SCHEMATIC FRAMING PLAN - 2ND FLOOR - 02.09.2022

101 W 33RD STREET  
BRYAN, TX 77803

SCHEMATIC FRAMING PLAN - 3RD FLOOR - 02.09.2022  
101 W 33RD STREET  
BRYAN, TX 77803

1 ST01 SCHEMATIC FRAMING PLAN - 2ND FLOOR  
3/16" = 1'-0"

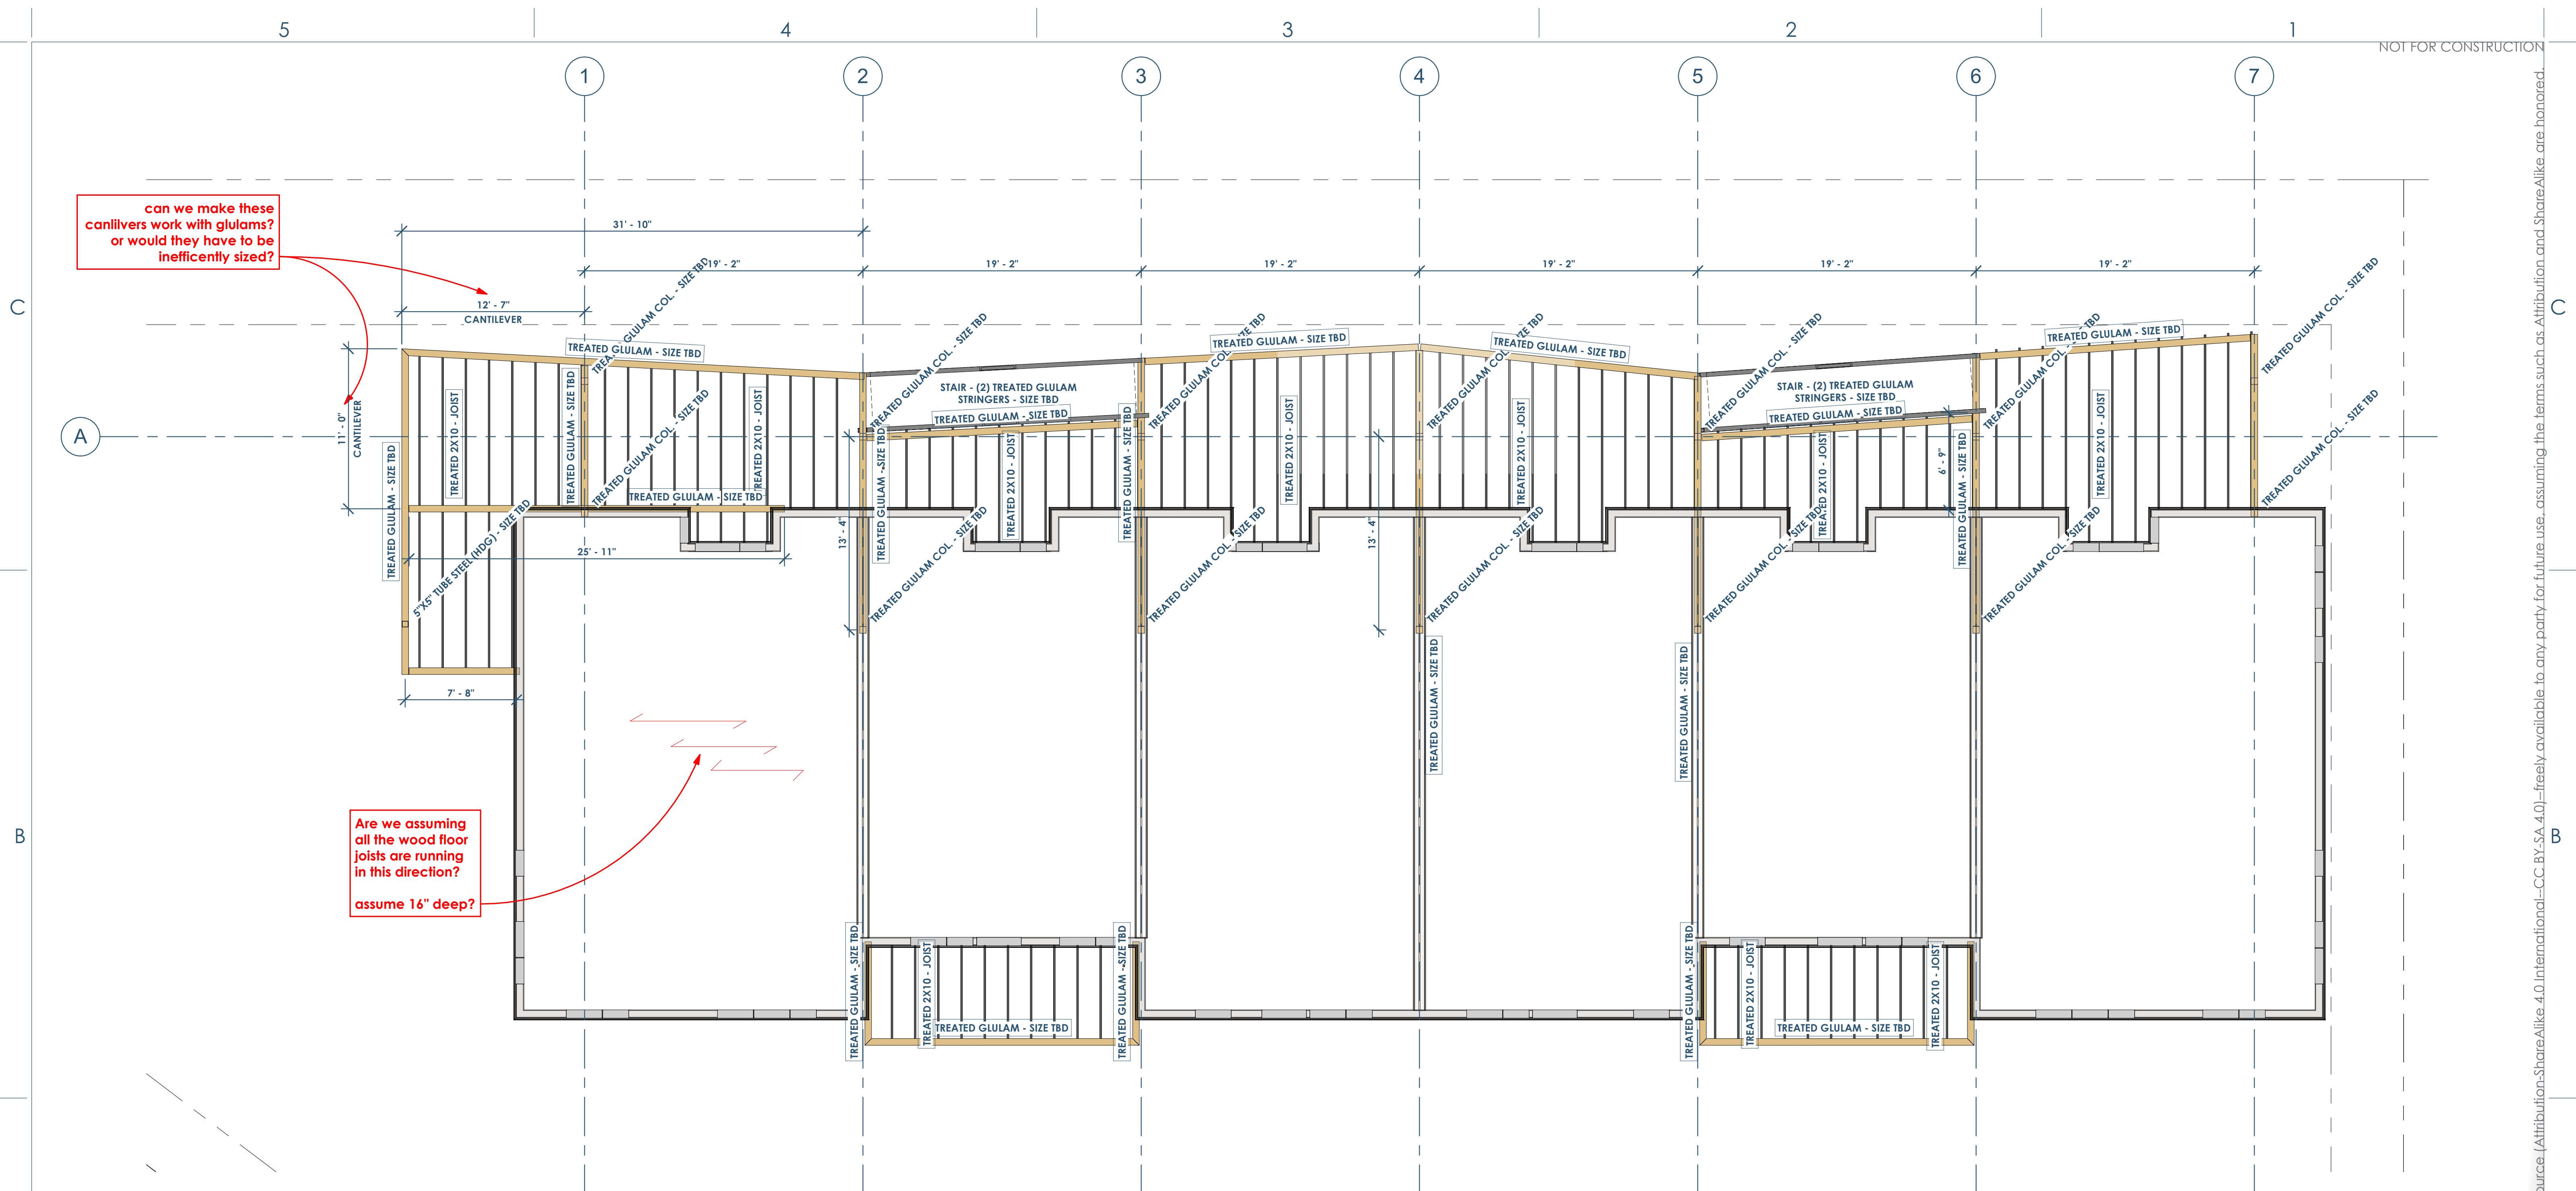
can we make these cantilevers work with glulams? or would they have to be inefficiently sized?

Are we assuming all the wood floor joists are running in this direction? assume 16" deep?

1 S102 SCHEMATIC FRAMING PLAN - 3RD FLOOR 3/16" = 1'-0"

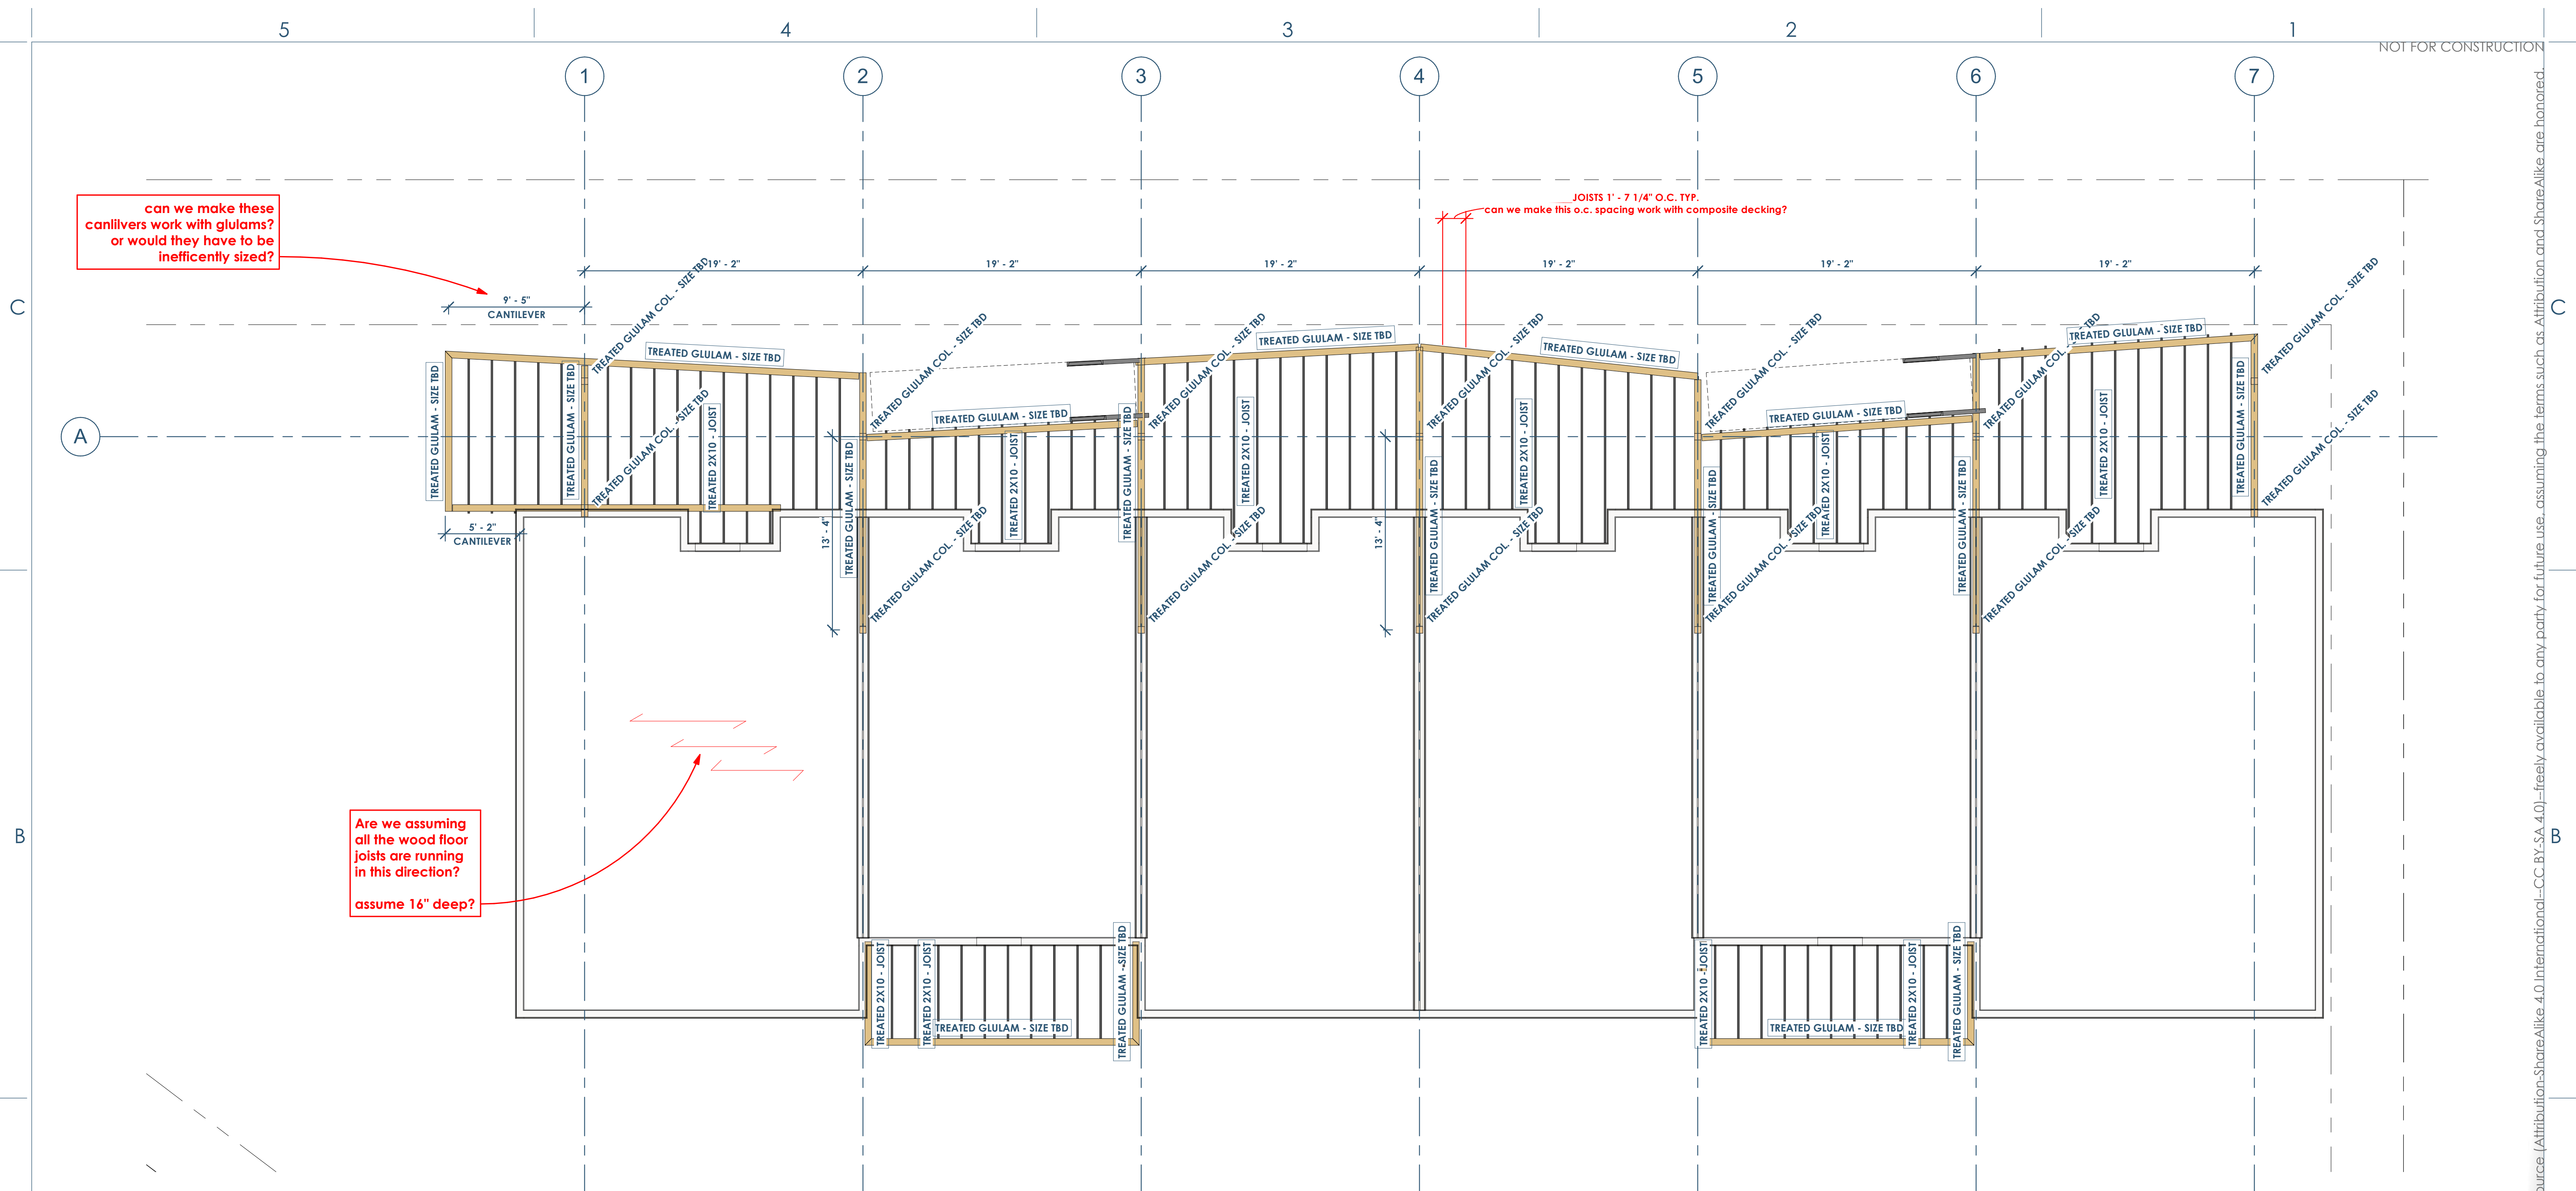
can we make these cantilevers work with glulams? or would they have to be inefficiently sized?

JOISTS 1' - 7 1/4" O.C. TYP. can we make this o.c. spacing work with composite decking?

Are we assuming all the wood floor joists are running in this direction? assume 16" deep?

1 S103 SCHEMATIC FRAMING PLAN - ROOF  
3/16" = 1'-0"

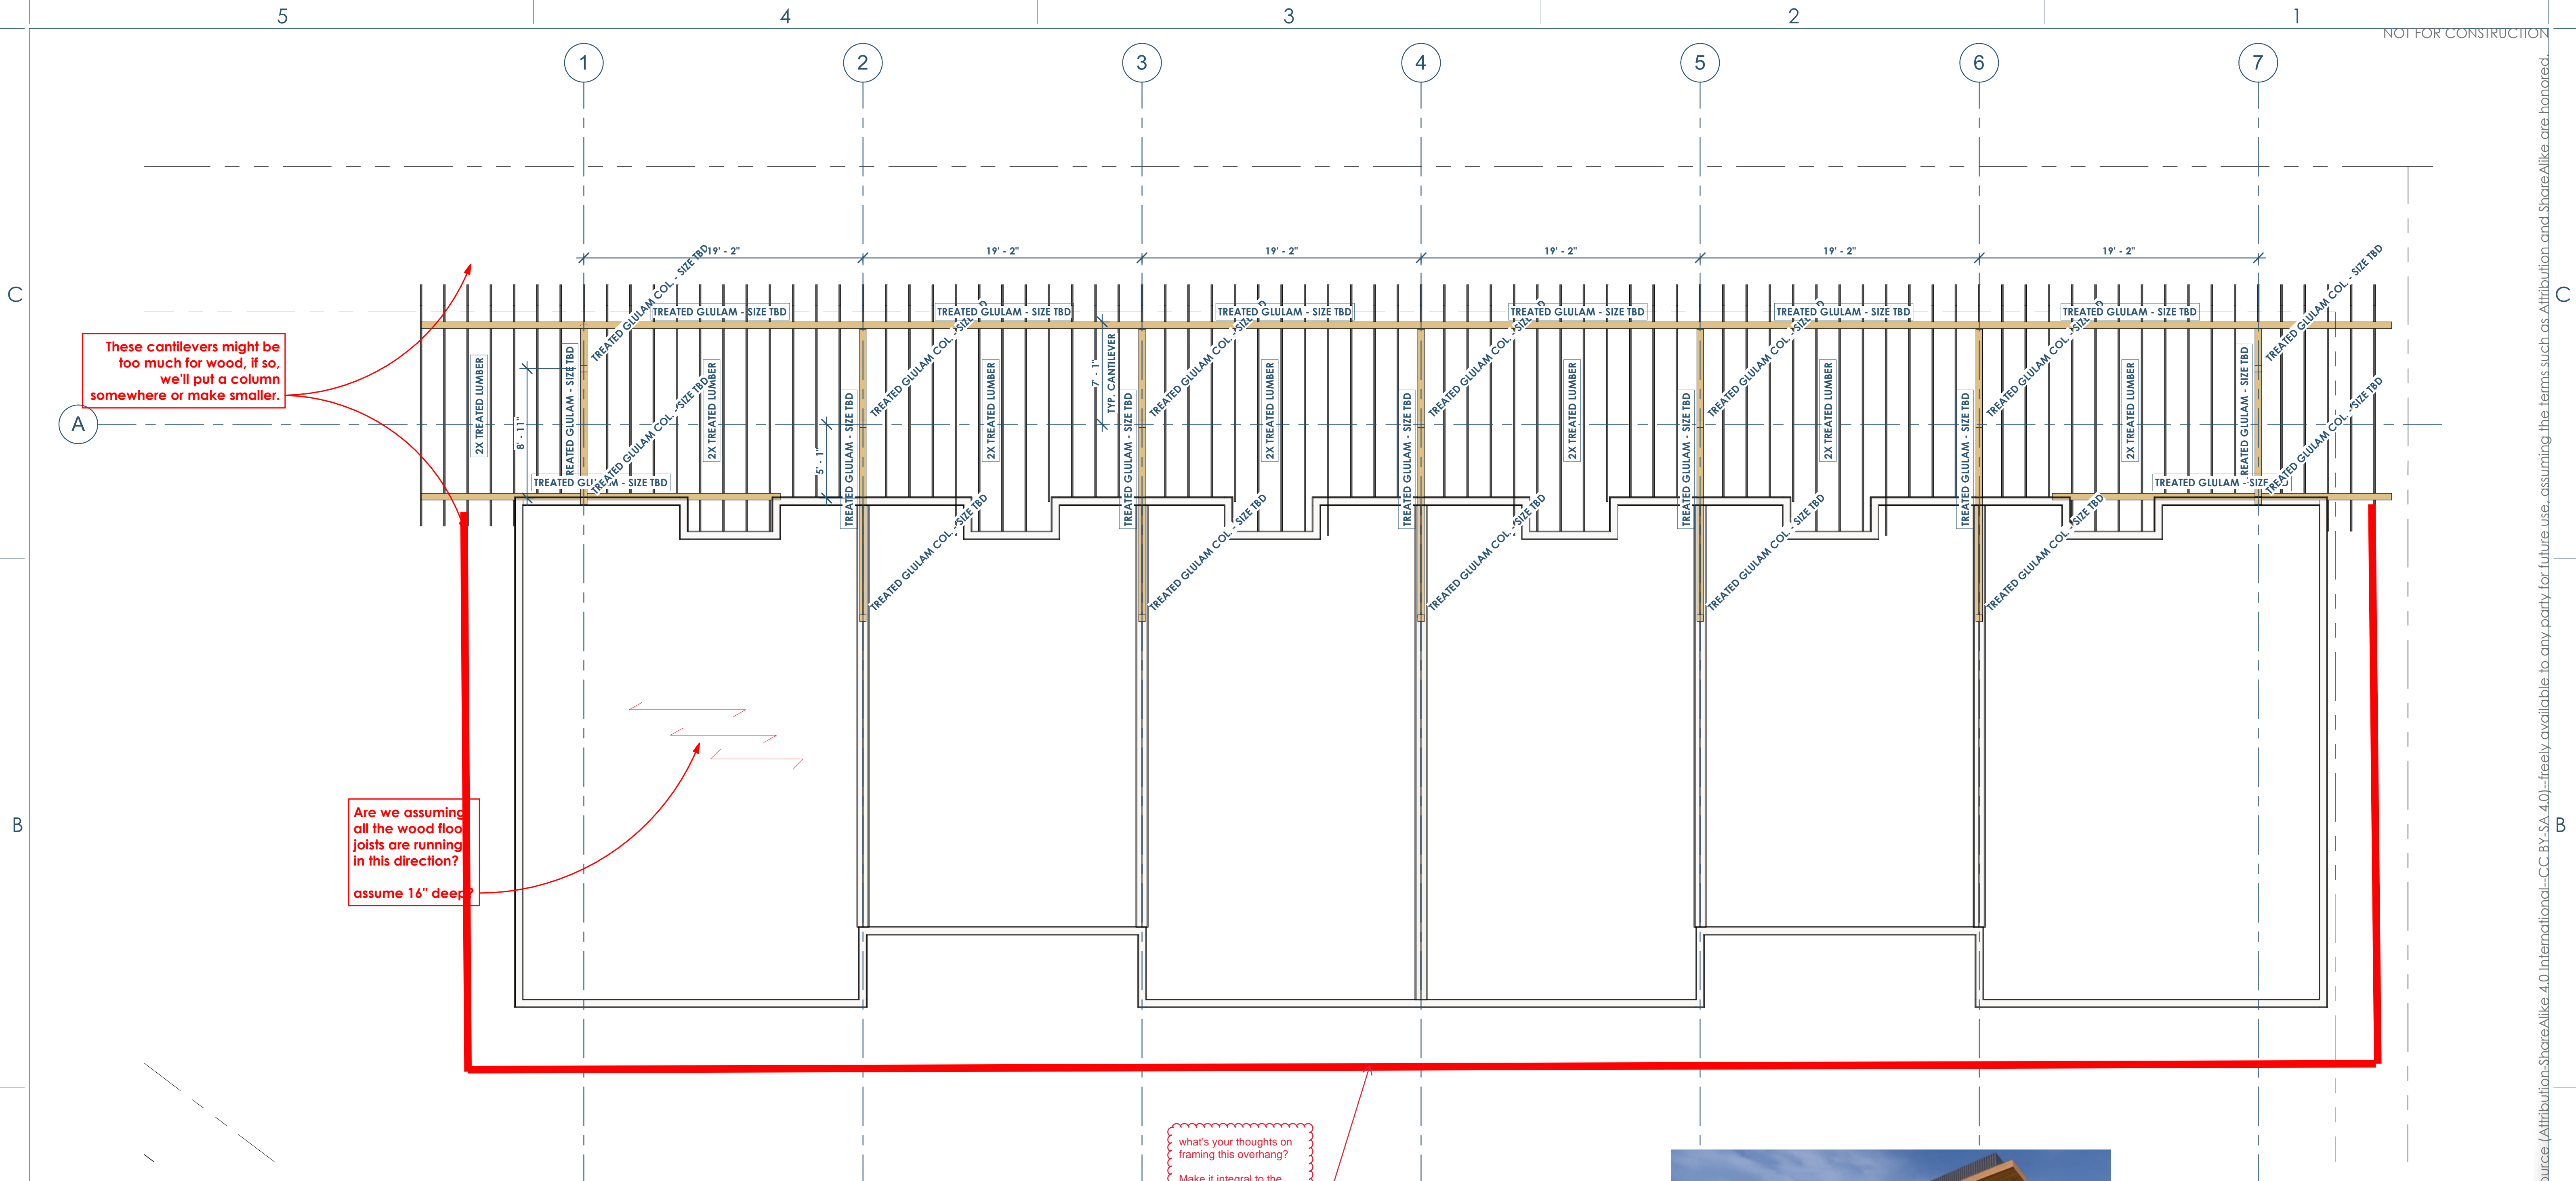
These cantilevers might be too much for wood, if so, we'll put a column somewhere or make smaller.

Are we assuming all the wood floor joists are running in this direction? assume 16" deep?

what's your thoughts on framing this overhang? Make it integral to the wood roof trusses? Make the parapet integral to the trusses as well?
